S E R V I C E N O T E

Agilent E4916A Crystal Impedance/LCR Meter

Serial Numbers: JP1KD00101 / JP1KD00841

DATE: September 2000

Figure 1. AC Line Connector

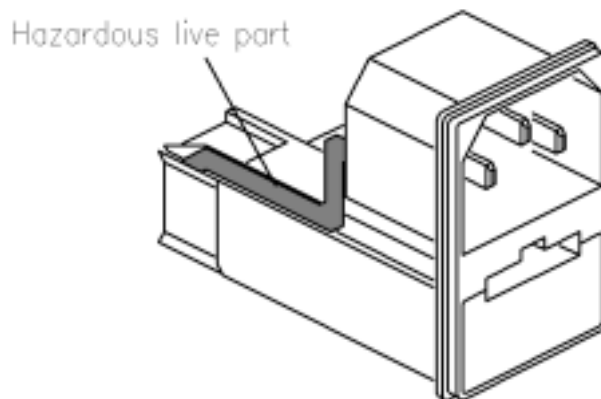
The AC inlet (P/N 1252-6951) has the potential to slip out of the instrument's rear panel slot if the AC power cord is forcefully pulled in a diagonal direction. When this happens, an exposed connection on the AC inlet module may touch the rear panel of the instrument and cause an electrical short if the AC power cord is still connected to the AC power outlet. See Figure 1.

In the worst case, there is also a possibility of an electric shock hazard to the user if the user completes a circuit between the instrument panel and another grounded connection while the AC power cord is still connected to the AC power outlet.

Solution 1. AC Inlet Still Intact.

- Remove the AC power cable from the AC power outlet and the product.
- Remove the top, bottom, and side covers.
- Seal the hot line terminal on the AC inlet with silicon paste (P/N 5183-4112).
- Reinforce the connection between the AC inlet and the rear panel with silicon paste.
- Perform Self Test to verify instrument operation.
